**ADDENDUM NO. 2**

Date of Addendum: February 7, 2023

Project Name: Gaston County Schools – Grier Middle School

- A. Owner: Gaston County Schools
- B. Architect: LS3P
- C. Architect Project Number: 9201-218240

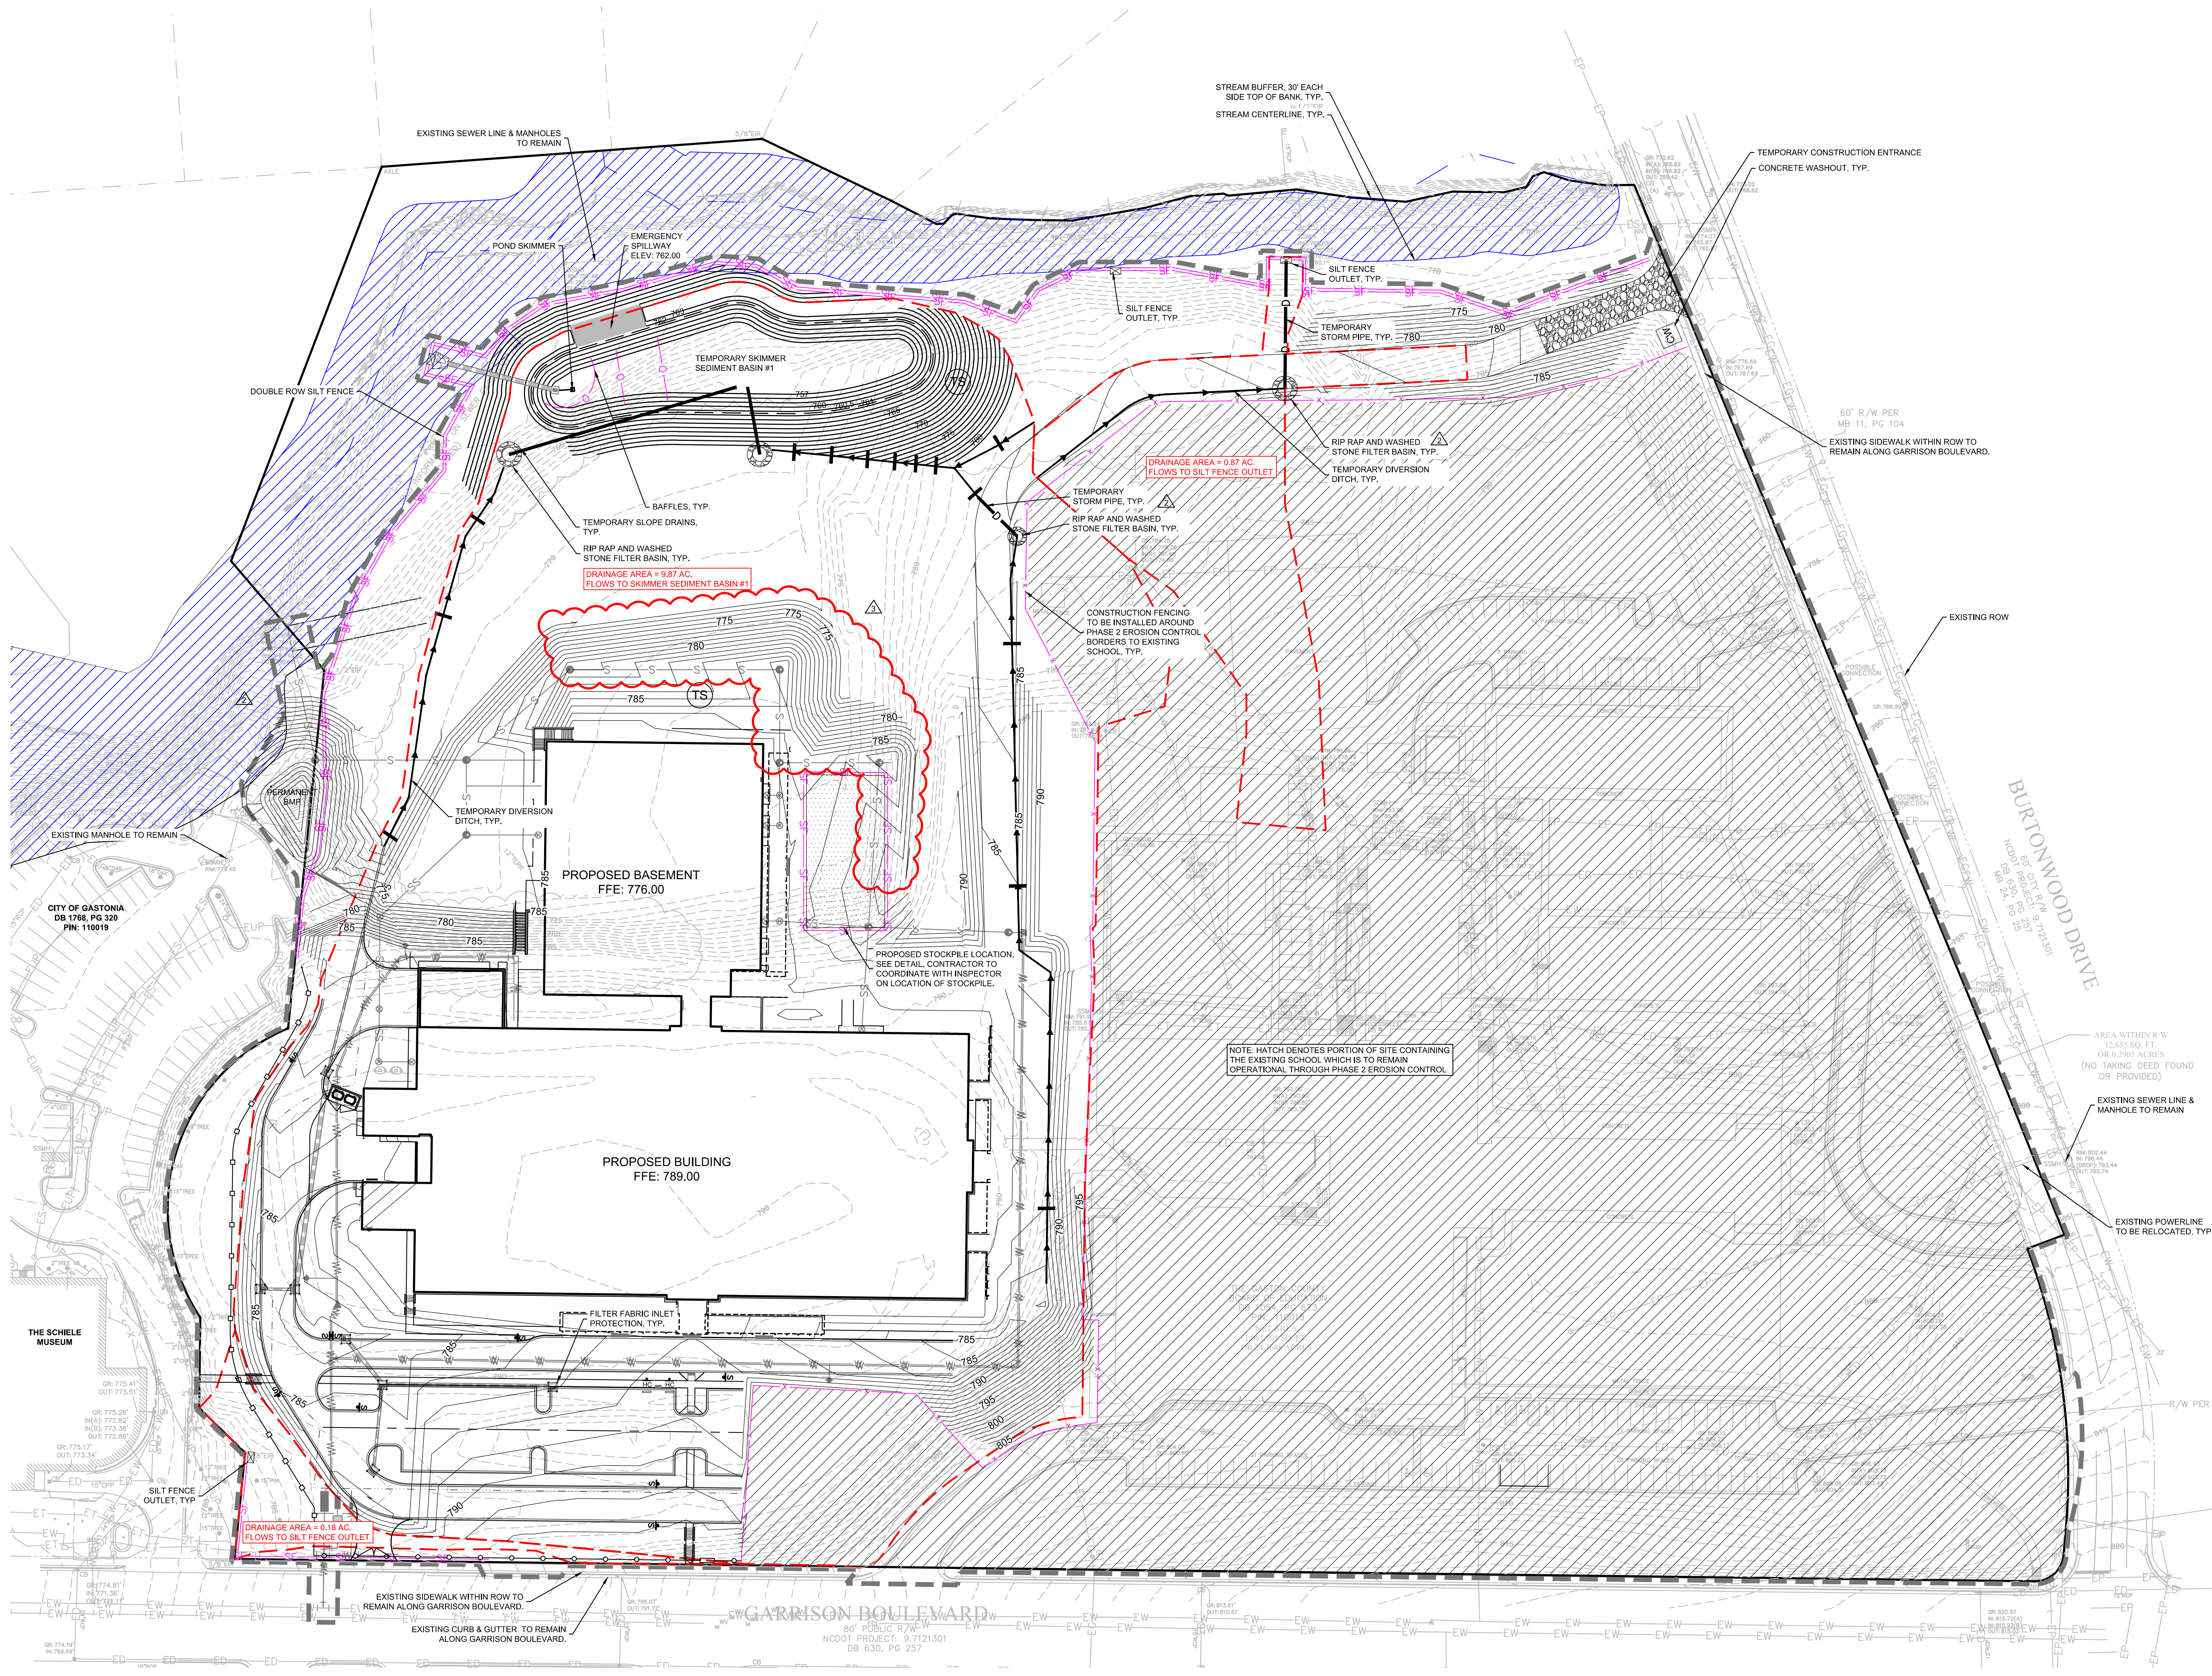
1. Remove temporary fill over sewer.
- C. Replace SHEET C3.1 – E&SC PHASE 2 with revised Sheet C3.1, included in the attachments.
1. Adjust surface grade at sewer manholes as indicated.

**C3.2**

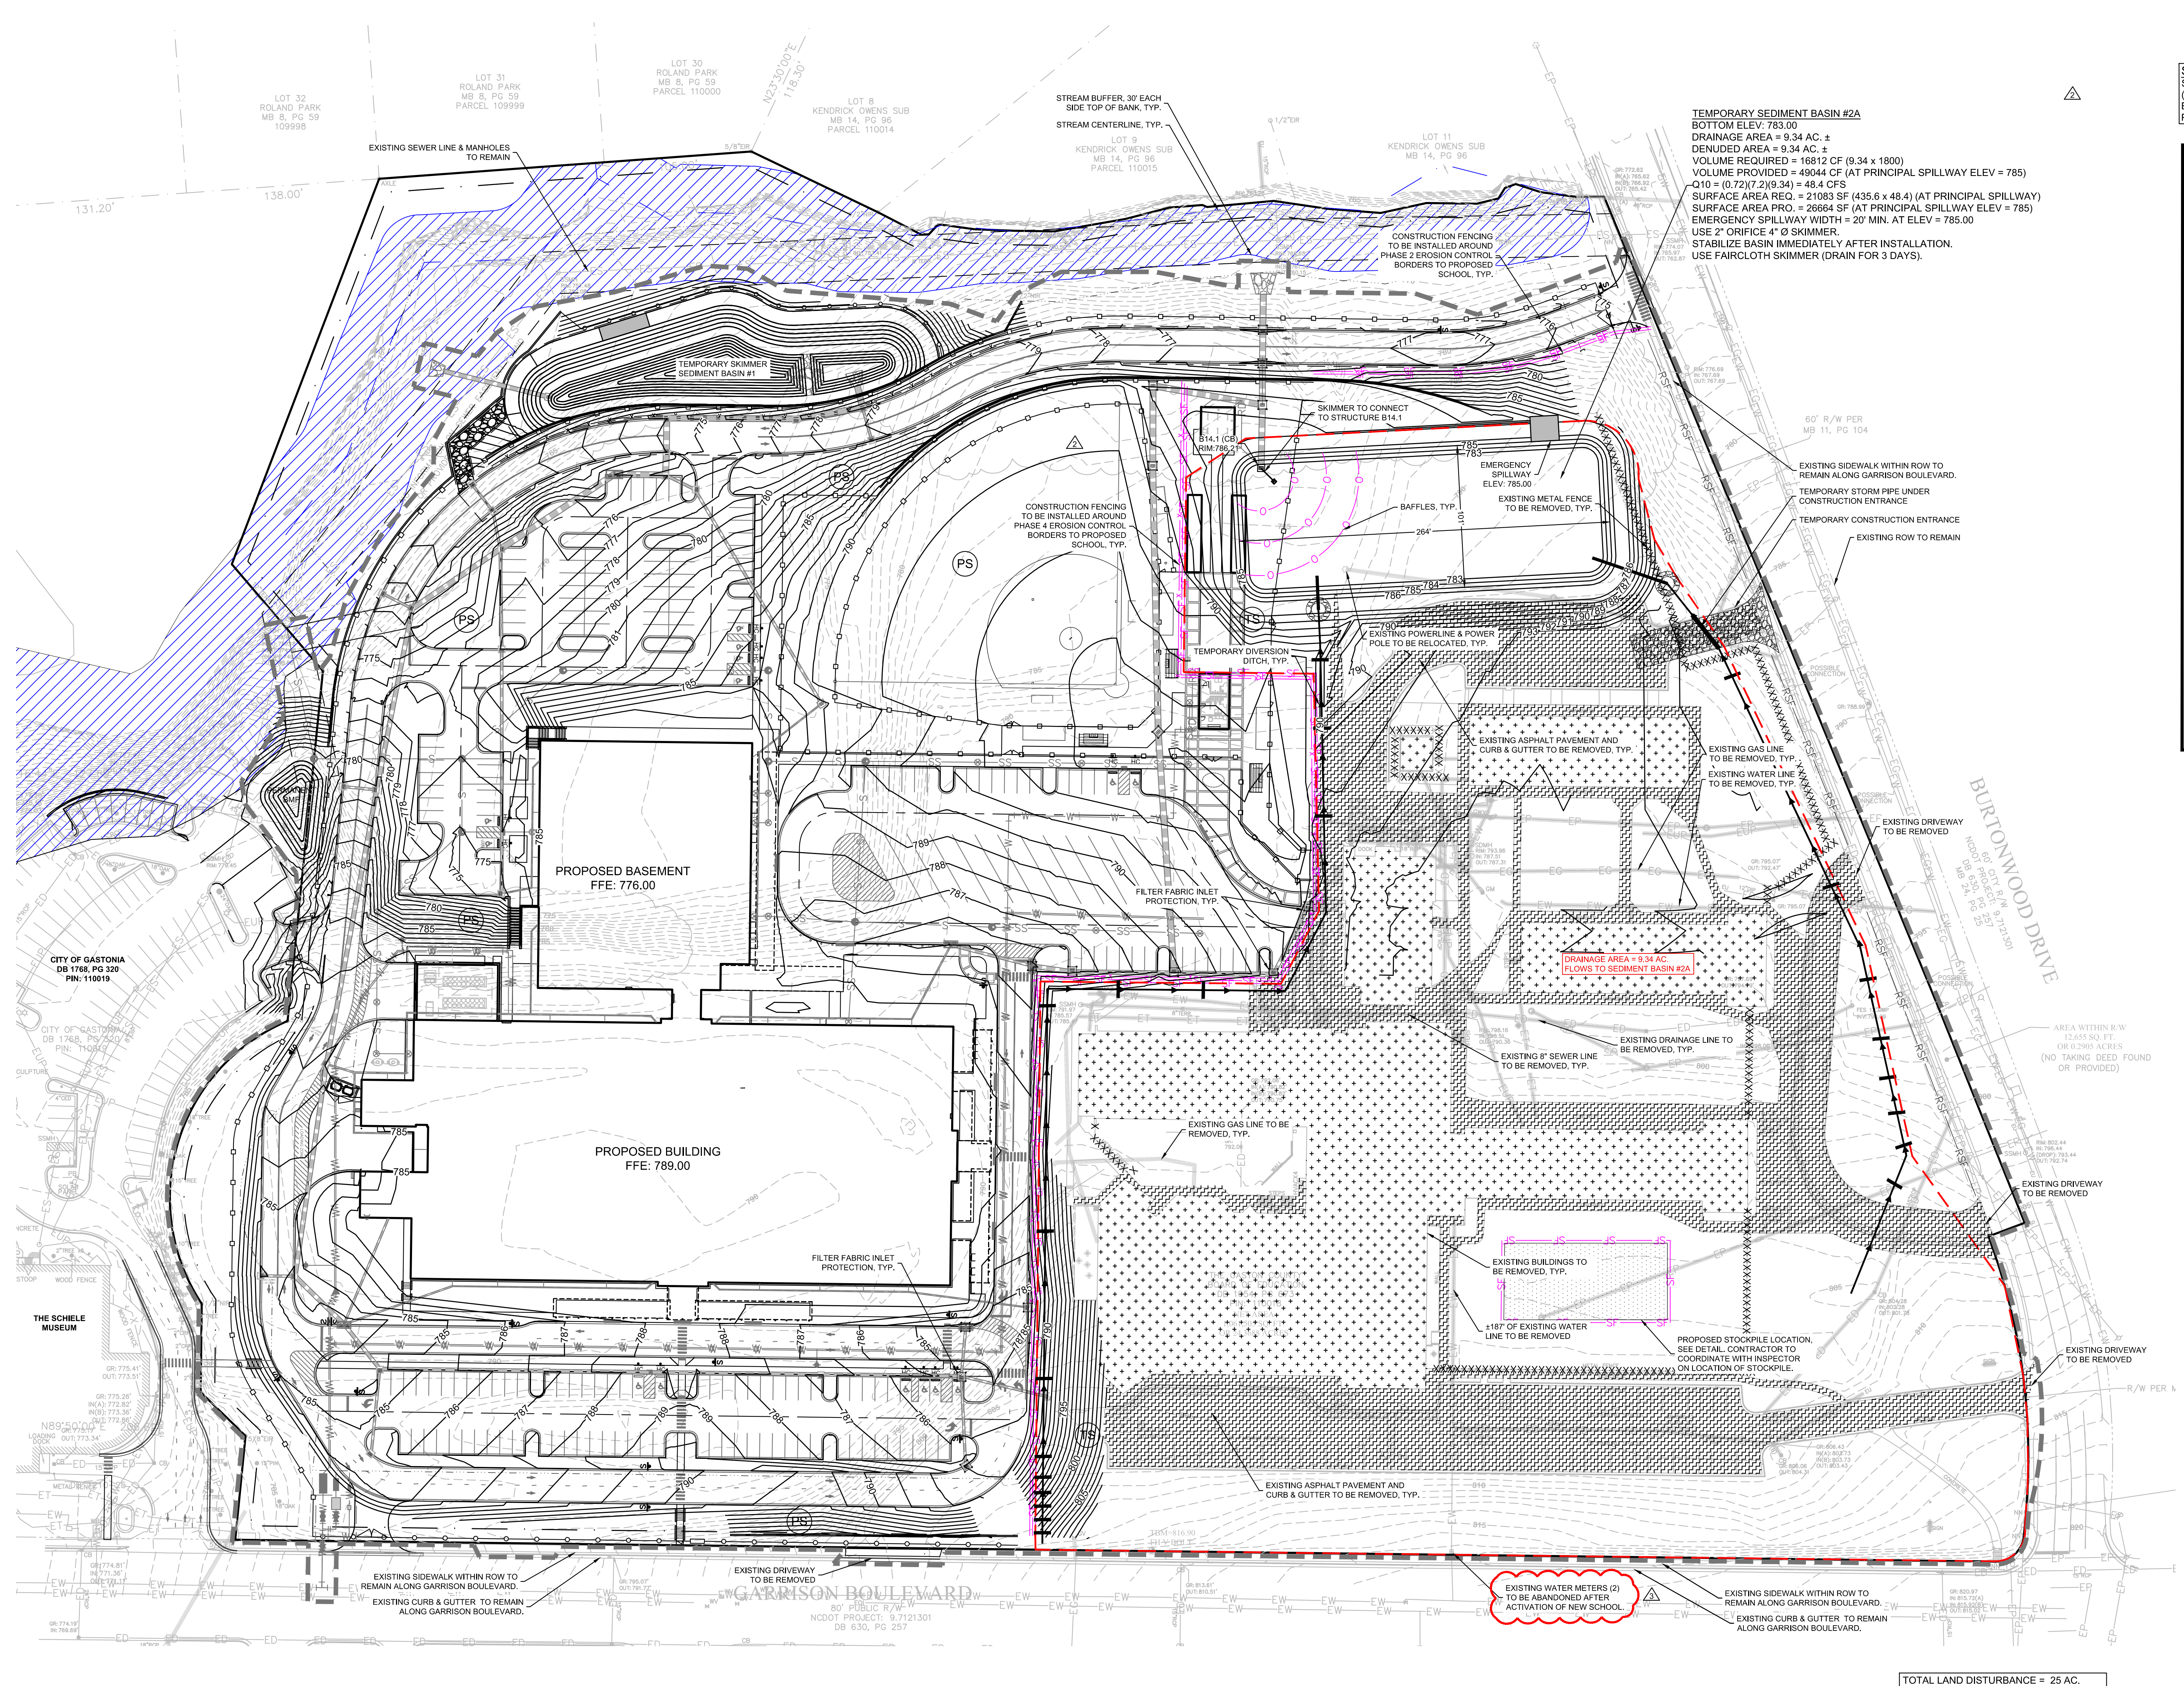
- D. Replace SHEET C3.2 – E&SC PHASE 3 with revised Sheet C3.2, included in the attachments.
1. Update label to reflect new survey information (2 water meters found in same vault).

2. Adjust surface grade at sewer manholes as indicated.
- E. Replace SHEET C3.3 – E&SC PHASE 4 with revised Sheet C3.3, included in the attachments.
1. Update label to reflect new survey information (2 water meters found in same vault).

**OVERALL GRADING PLAN**  
**C6.0**

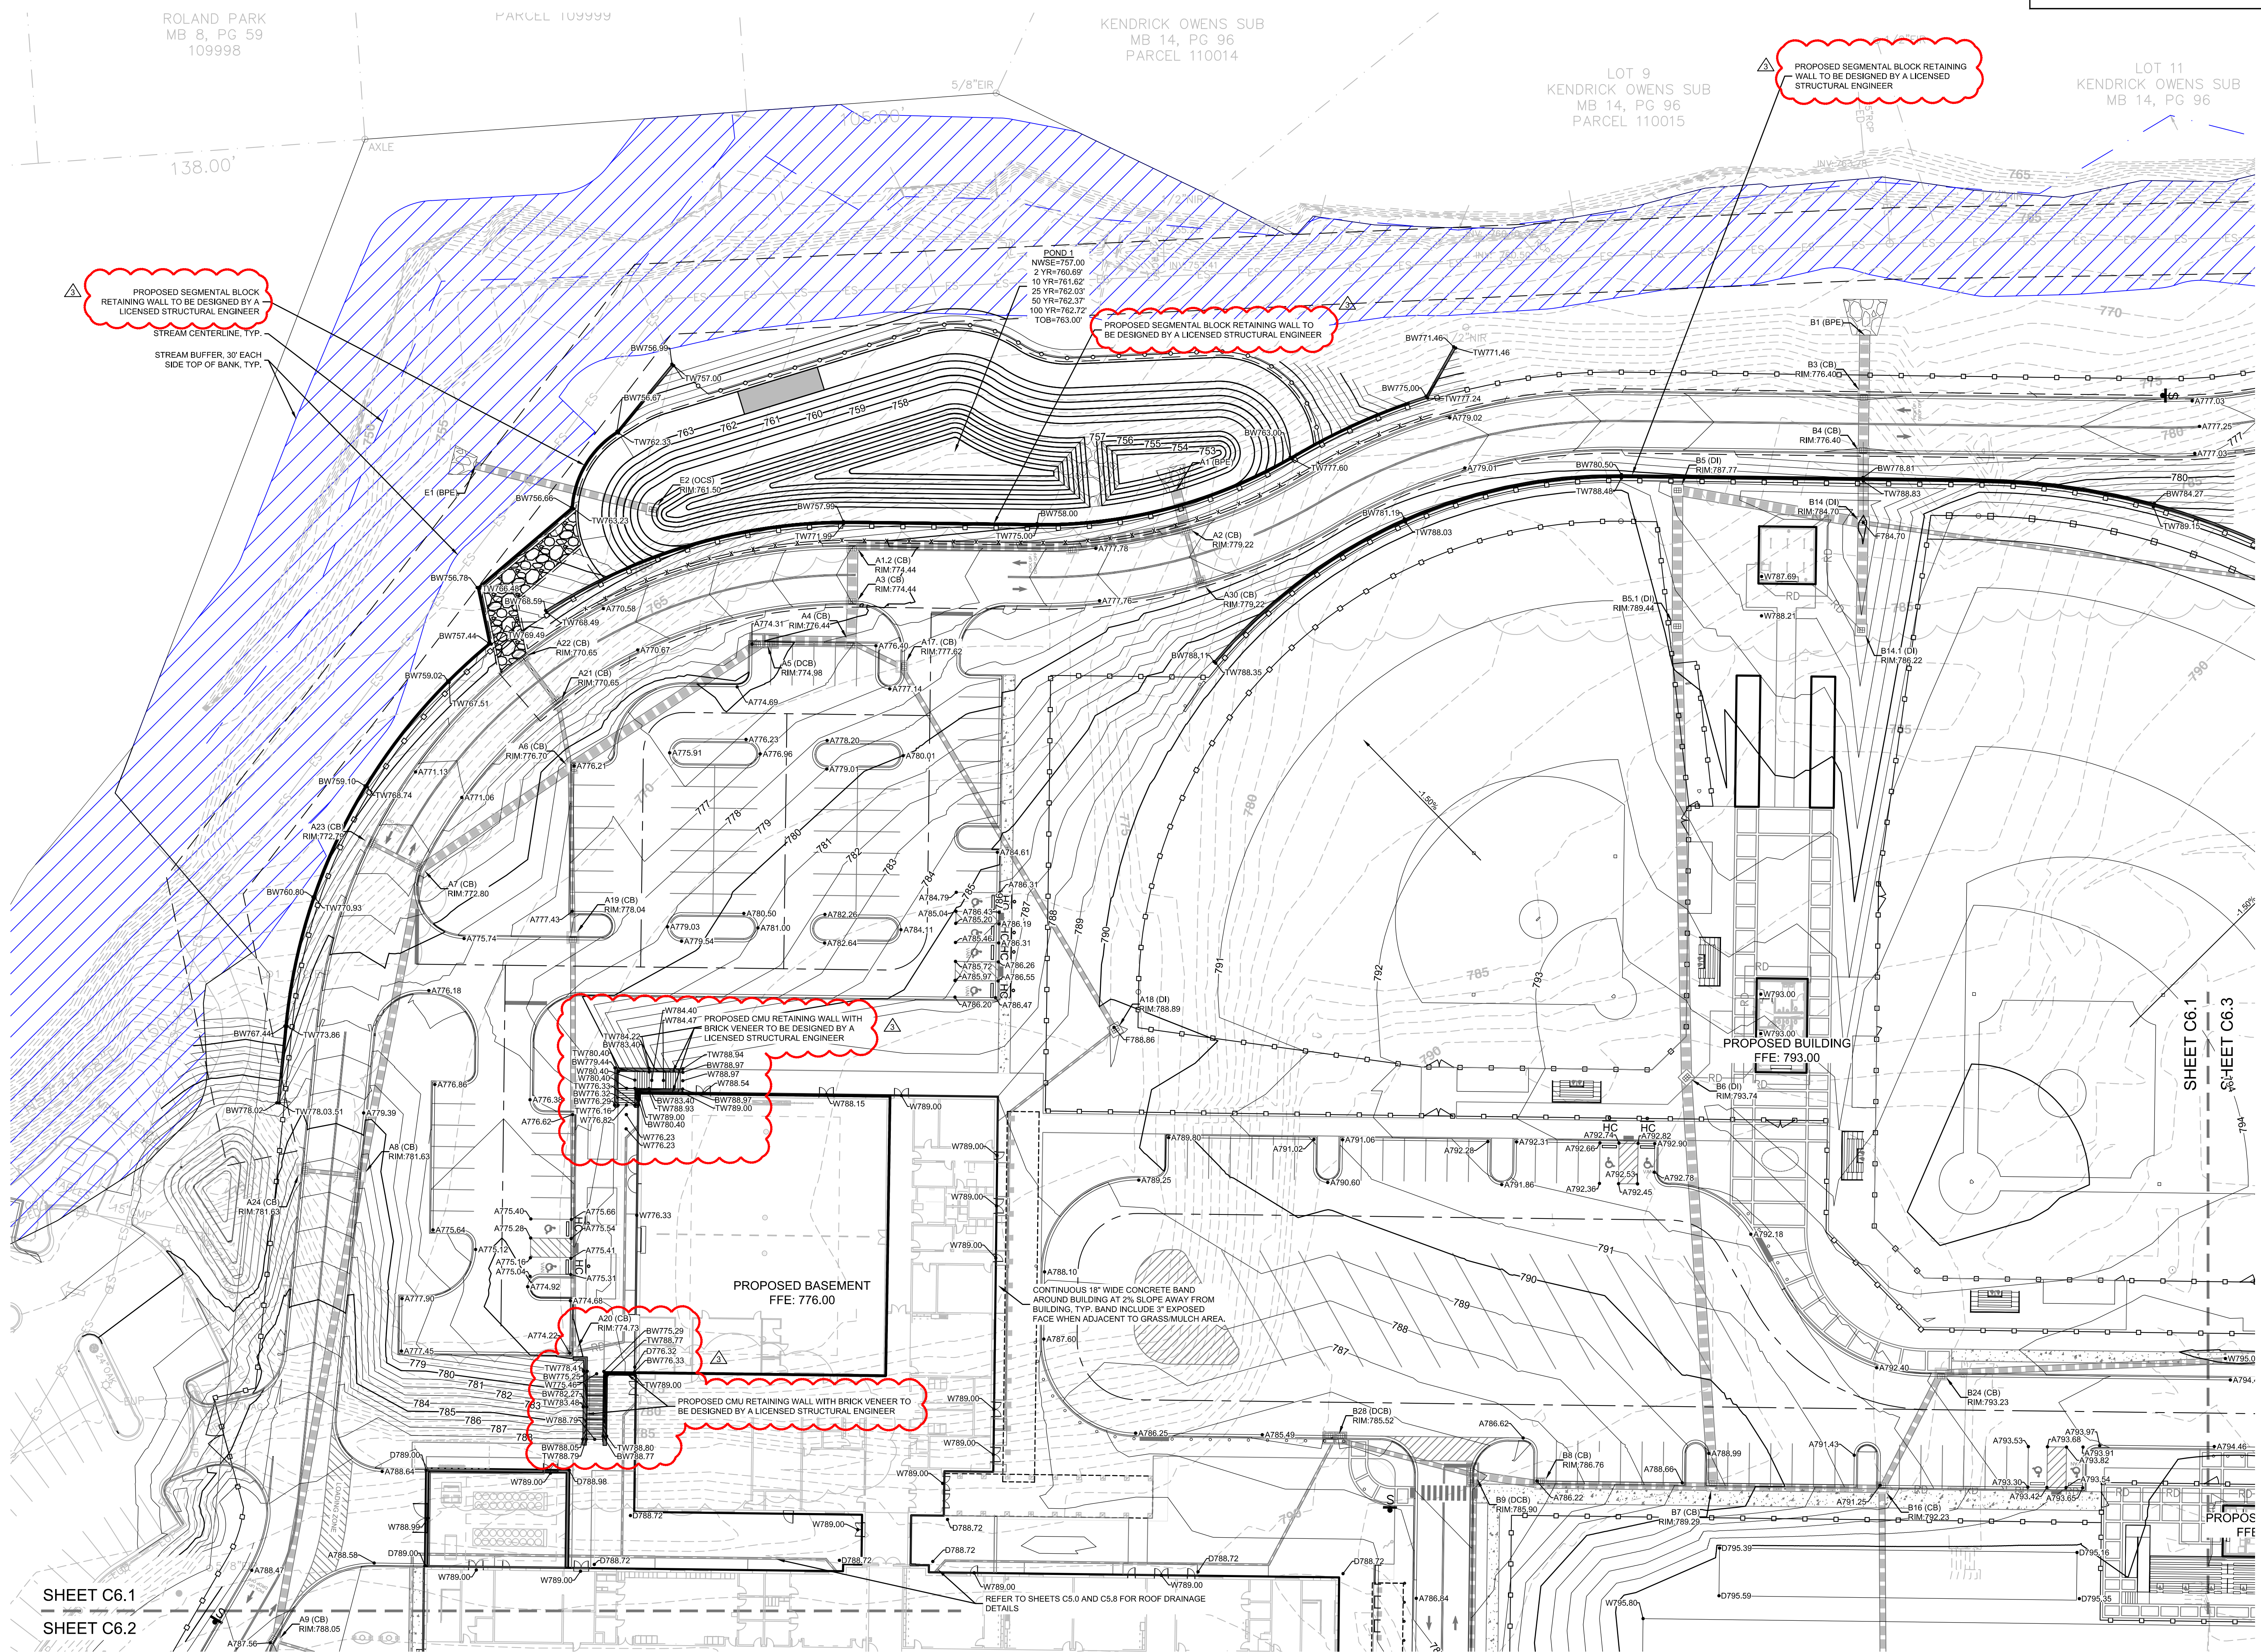
3. Stair at NW of basement removed stairs and reduced retaining wall.
  4. Removed 2 flag poles. Only 1 flag pole remaining.
- G. Replace SHEET C6.0 – OVERALL GRADING PLAN with revised Sheet C6.0, included in the attachments.

1. Specify types of retaining walls.
- H. Replace SHEET C6.1 – ENLARGED GRADING PLAN with revised Sheet C6.1, included in the attachments.
1. Specify types of retaining walls.
